Access Compliance Report

Public Rights-of-Way

(Curb Ramps)

Intersection ID: 11349	Main Street: N_DAVIDSON_ST	Cross Street: PARKWOOD_AV	Location: S
ADA ID: 1F2AE39A39D8	Ramp Type: Perp	Initial Pass/Fail: Fail	Overall Compliance: No
Severity Score: 8.75			
Codes/Mitigation Info/Possible Solution		Field Measurements/Component Compliance

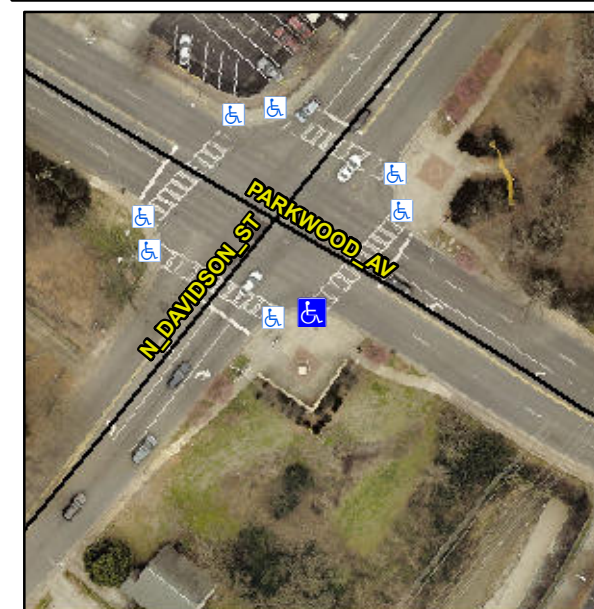
Not Found, R304.5.1

Compliance	Description	Data	Compliance	Description	Data
N/A	Ramp Length (in)	66.5	Yes	Ramp Slope (%)	6.9
No	Ramp Width (in)	47.5	Yes	Ramp XSlope (%)	1.8
N/A	Flare Type LT	N/A	N/A	Flare Type RT	N/A
N/A	Flare Slope LT (%)	N/A	N/A	Flare Slope RT (%)	N/A
N/A	Flare Traversable LT?	N/A	N/A	Flare Traversable RT?	N/A
N/A	Landing Length (in)	N/A	N/A	DWS Provided?	N/A
N/A	Landing Width (in)	N/A	N/A	DWS Contrast?	N/A
N/A	Landing Slope (%)	N/A	N/A	DWS Length (in)	N/A
N/A	Landing X Slope (%)	N/A	N/A	DWS Full Width?	N/A
N/A	Landing Curb? (Y/N)	N/A	N/A	DWS Offset (in)	N/A
N/A	Shared Landing?	N/A			
N/A	Gutter Ponding?	N/A	N/A	Gutter Slope (%)	N/A
N/A	Gutter Lip Ht (in)	N/A	N/A	Gutter X Slope (%)	N/A
N/A	Painted X Walk1?	Yes	N/A	Painted X Walk2?	N/A
	X Walk 1 Direction	To NE		X Walk 2 Direction	N/A
N/A	X Walk 1 Width (in)	107.0	N/A	X Walk 2 Width (in)	N/A
	X Walk 1 Slope (%)	0.5		X Walk 2 Slope (%)	N/A
	X Walk 1 X Slope (%)	0.5		X Walk 2 X Slope (%)	N/A

Remove & Replace Entire Ramp.
